RE: **Crivella Property**
Response to PLUS Review-2017-01-05
Tax Map No.: 5-33-11.00-82.00
DBF #818C027

We have read and reviewed the comments provided during the PLUS Review of the Project on October 25, 2017, and received from the Office of State Planning dated November 27, 2017. We offer the following item-by-item response narrative for your review:

Figure 1: NRCS soil survey mapping update in the immediate vicinity of the proposed construction

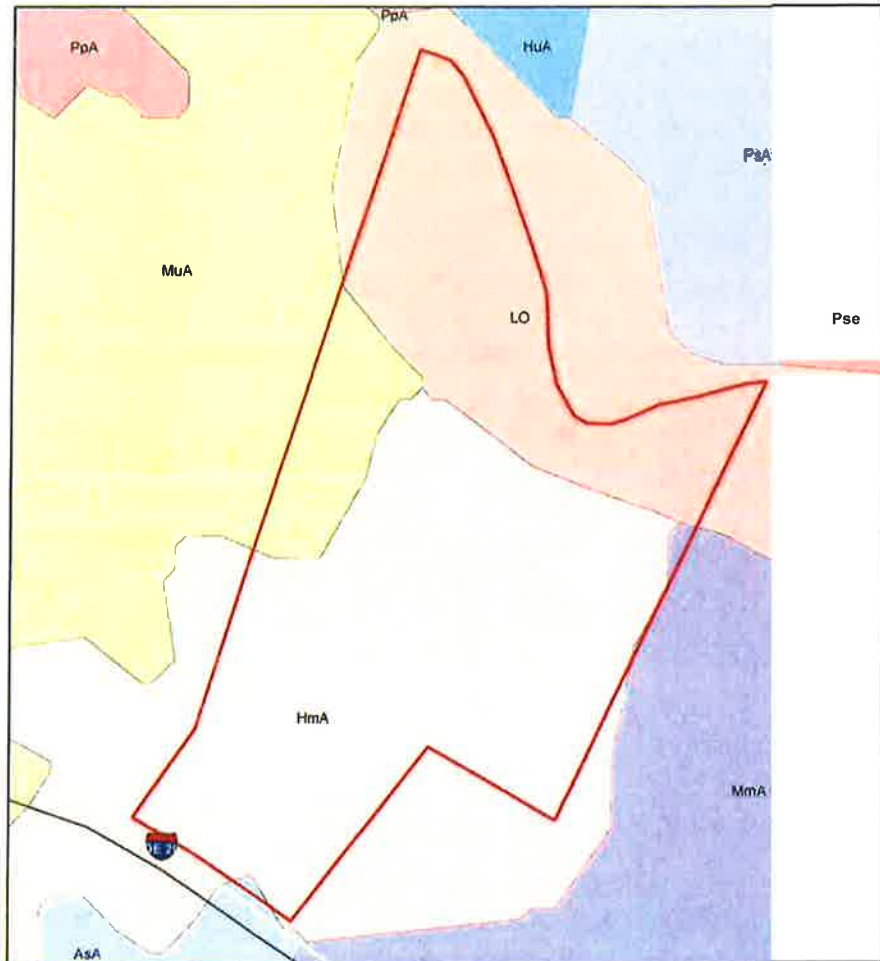
- Based on NRCS soils survey mapping update, the soil mapping units of concern are Mullica-Berryland complex (MuA) and Longmarsh (LO). Mullica-Berryland complex and Longmarsh are very poorly-drained wetland associated (hydric) soils with severe limitations for development (considered unsuitable for development; Figure 1).*

- DNREC strongly discourages building on hydric soils because they are functionally important source of water storage (functions as a "natural sponge"); the loss of water storage through excavation, filling, or grading of intact native hydric soils increases the probability for more frequent and destructive flooding events. The probability for flooding is further compounded by increases in surface imperviousness as building density in the area increases over time. Moreover, destruction/filling of hydric soils increases the amount pollutant runoff (i.e., hydric soils sequester and detoxify pollutants) which contributes to the decline in water quality in regional waterbodies and wetlands.*

The site has been designed to avoid the majority of the hydric soils. The rear of the site will remain largely woods areas with wetland areas protected by a 40' buffer.
